THE MEMPHIS DEPOT TENNESSEE

SUBJECT: Response to Comments on the Record of Decision for
Groundwater Interim Remedial ActionMr. Joseph R. Franzmathes, Director
Waste Management Division
U.S. Environmental Protection Agency
345 Courtland St., NE
Atlanta, GA 30365

Subject: Transmittal of DDMT Interim Record of Decision (ROD)
Comment Response Table

EPA Comments
Draft ROD for Interim Record of Decision
of the Groundwater at Dunn Field-DDMT
August 1995, CH2M HILL

FIGURE 3
GENERALIZED CONCEPTUAL SITE MODEL (CROSS SECTION VIEW)
Defense Depot, Memphis, Tennessee

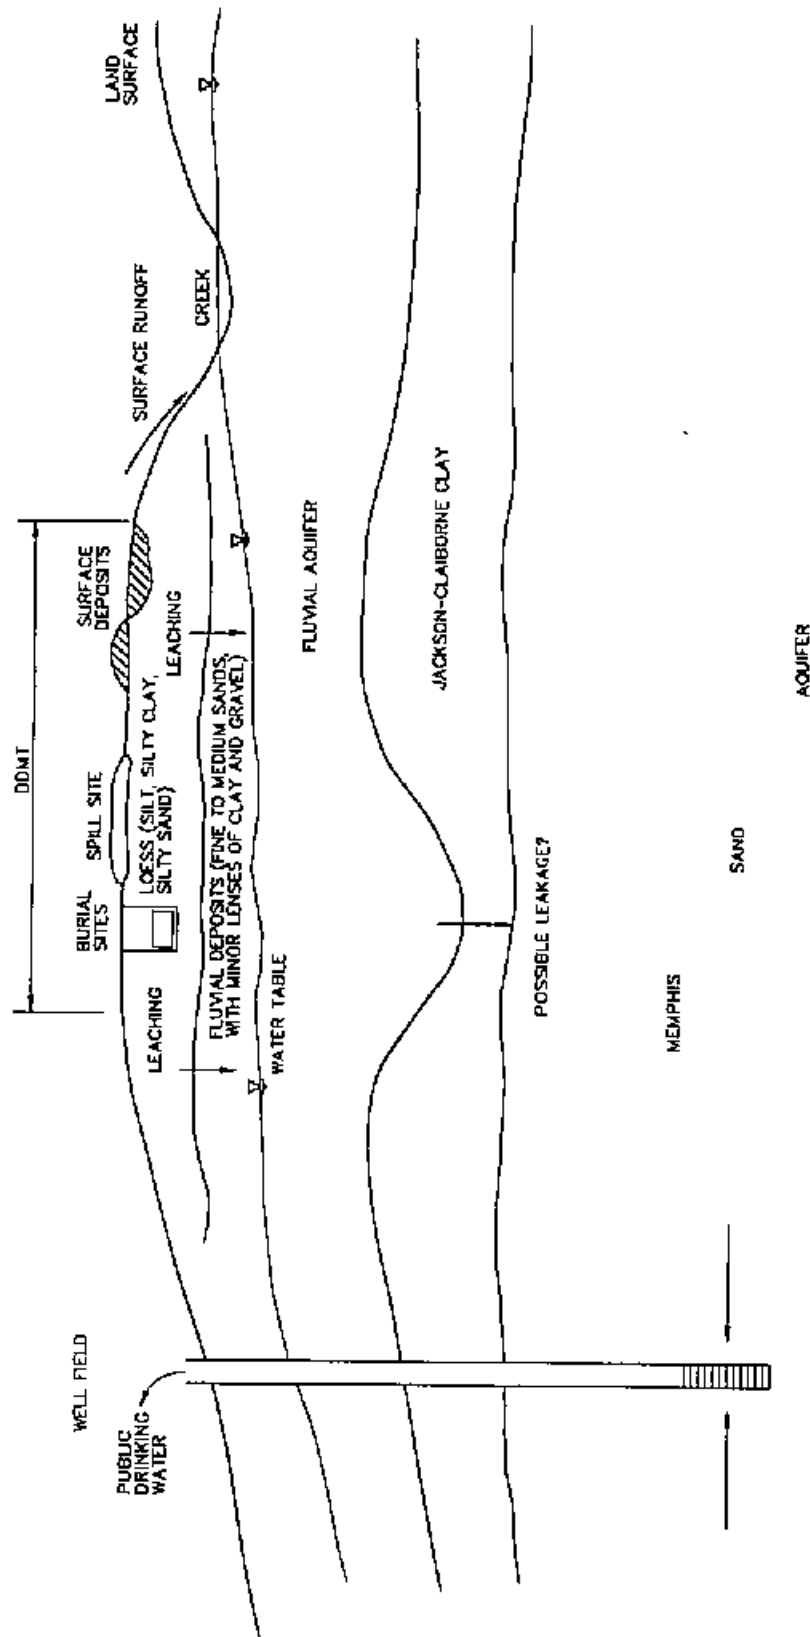
In addition to the comment response table, I am including text from a new section (Section 2.10-Statutory Determinations) requested in one of the comments, a revised Figure 3-Conceptual Site Model, and revised ARARs tables. These items seem to be the most important for your review.
